CHANGE ORDER NO. 9

<b>PROJECT:</b>	<b><u>Horizon City Municipal Facilities Phase I</u></b>	<b>DATE OF ISSUANCE:</b>	August 12, 2025
<b>OWNER:</b>	TOWN OF HORIZON CITY 14999 Darrington Rd. Horizon City, Texas 79928	<b>EFFECTIVE DATE:</b>	<b>August 12, 2025</b>
<b>CONTRACTOR:</b>	<b><u>Dantex General Contractors</u></b> <b><u>4727 Osborne</u></b> El Paso, TX 79922	<b>OWNER'S BID NO.</b>	CSP 23-038 Project No. 2.513D
<b>CONTRACT FOR:</b>	<i>New Municipal Facilities for the City of Horizon</i>	<b>ARCHITECT:</b>	Eugenio Mesta, AIA Exigo Architects 211 N. Florence Ste. A El Paso, Tx 79912
		<b>ARCHITECT'S PROJECT NO:</b>	20201600

**YOU ARE DIRECTED TO MAKE THE FOLLOWING CHANGE TO THE CONTRACT DOCUMENTS:**Item No. 1: **Additional Structural Roof Supports** - (\$10,726.08; 0 days impact to contract time)**PURPOSE OF CHANGE ORDER:**

**To:** DANTEX Construction  
**From:** Jesus Ortega, EXIGO Architects  
**Project:** Horizon Municipal Facilities  
**Date:** June 12, 2025  
**Re:** **ASI 002 – Roof-mounted Radio Antennas.**

**S201**

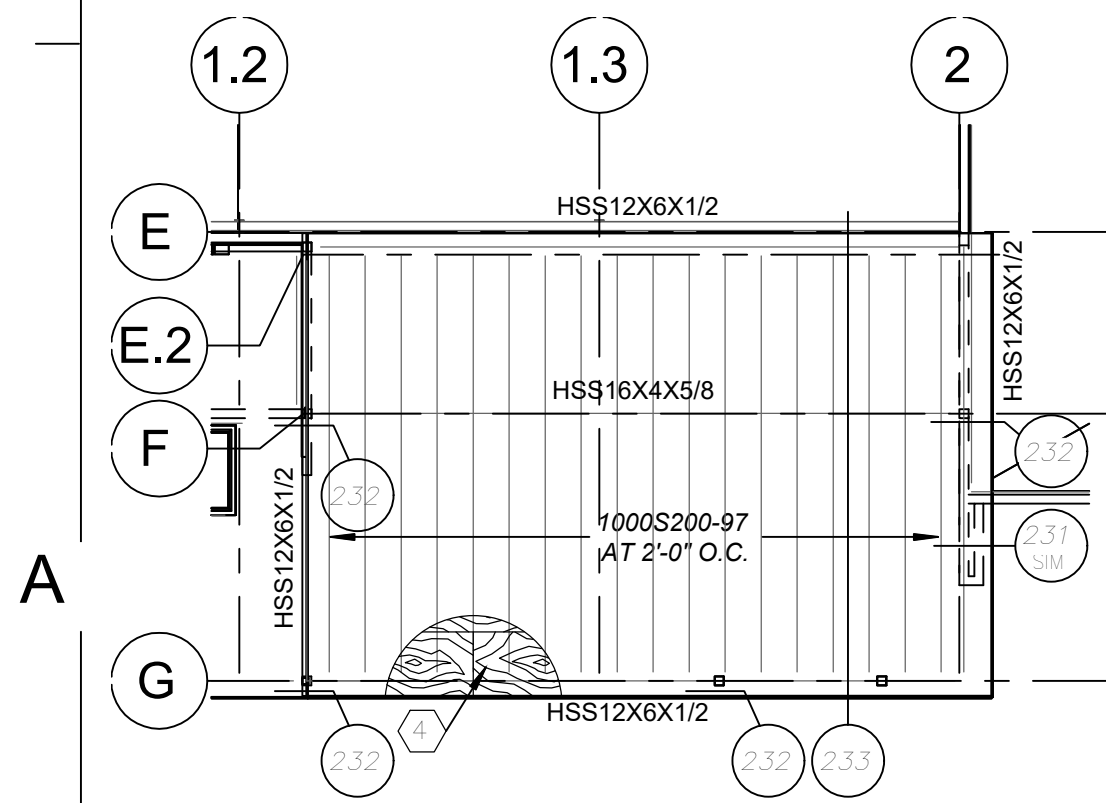
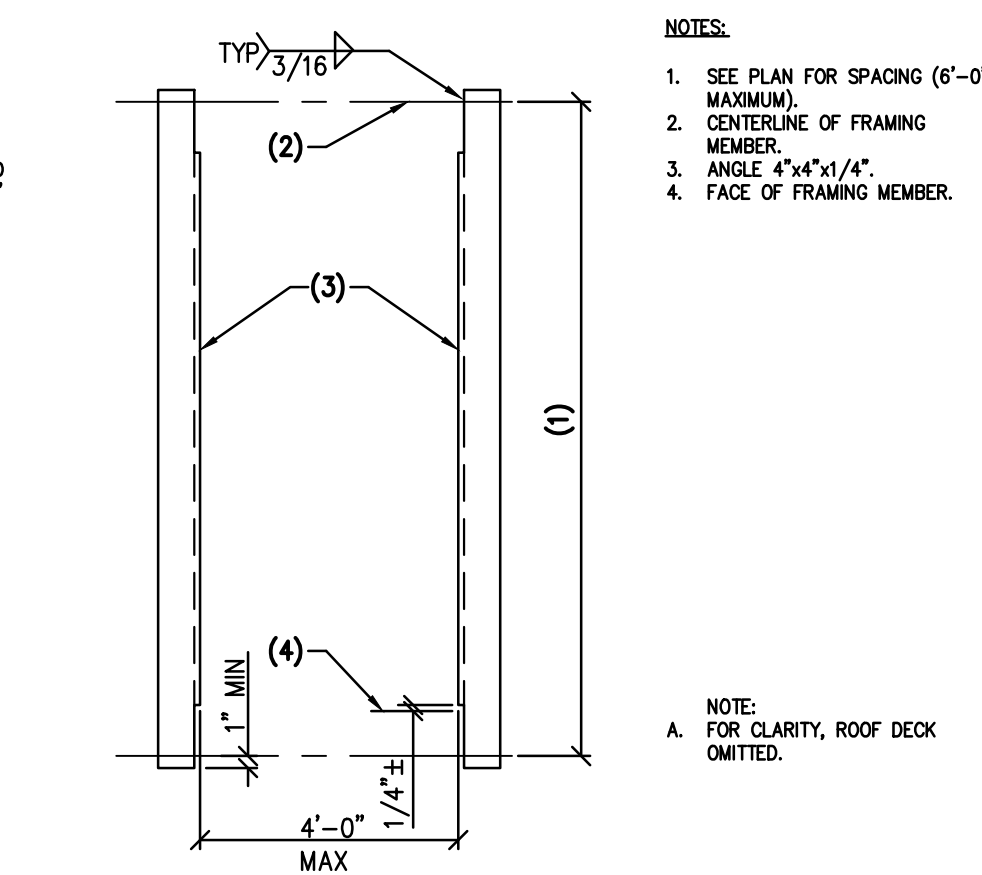
- a) Sheet S201– Roof Framing Plan – Delta#1: Additional steel framing to support roof-mounted antennas for radio communication.

**48 PLAN - ANTENNA SUPPORT BETWEEN JOIST**  
NO SCALE

- NOTES:**
1. SEE PLAN FOR SPACING (6'-0" MAXIMUM).
  2. CENTERLINE OF FRAMING MEMBER.
  3. ANGLE 4"x4"x1/4".
  4. FACE OF FRAMING MEMBER.

**E4.0**

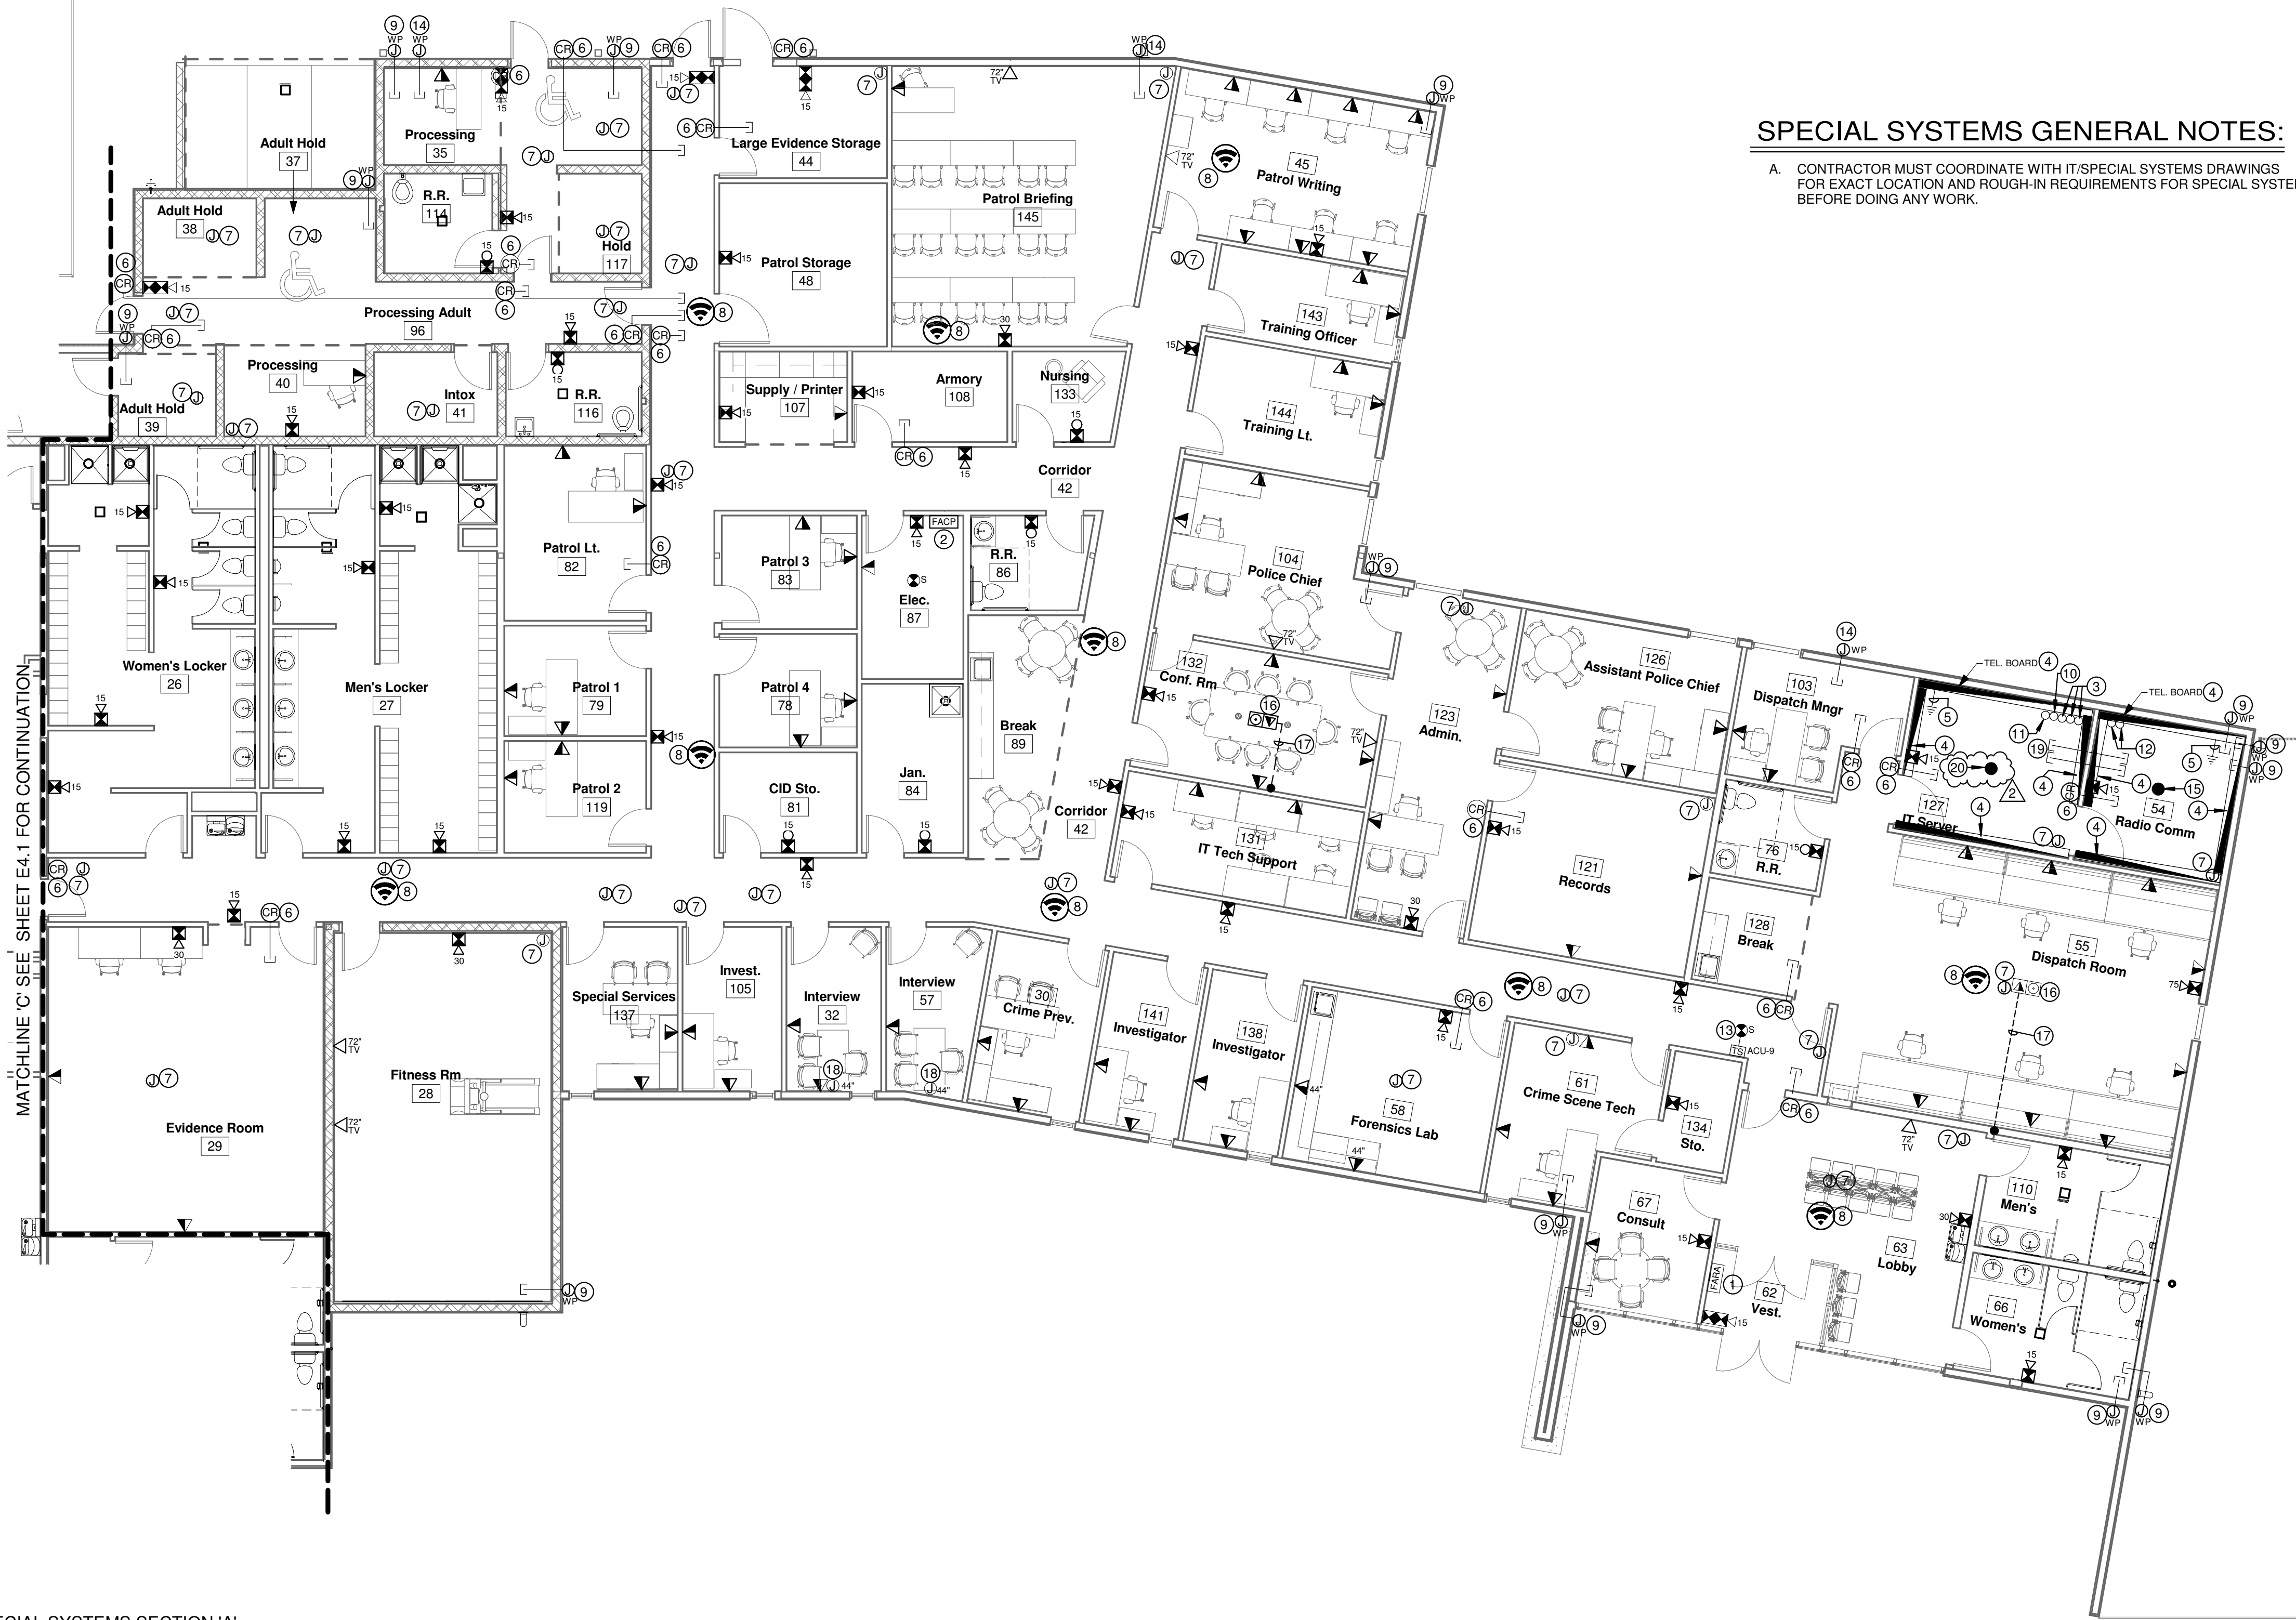
- a) Sheet E4.0 – Special Systems – Delta #2 – New conduit w/ weather head for IT cabling to roof.

- PROVIDE AND INSTALL A 4" CONDUIT FROM RADIO COMM. ROOM TO ROOF. STUB-UP CONDUIT AT 2FT. AFTER FINISH ROOF. PROVIDE AND INSTALL A WEATHER HEAD FOR A TOTAL OF SIX (6) COAXIAL CABLES. WEATHER HEAD TO BE KILLARK-HUBBELL HSTF- OR EQUAL. COORDINATE WITH IT/SECURITY CONTRACTOR FOR EXACT LOCATION AND REQUIREMENTS.
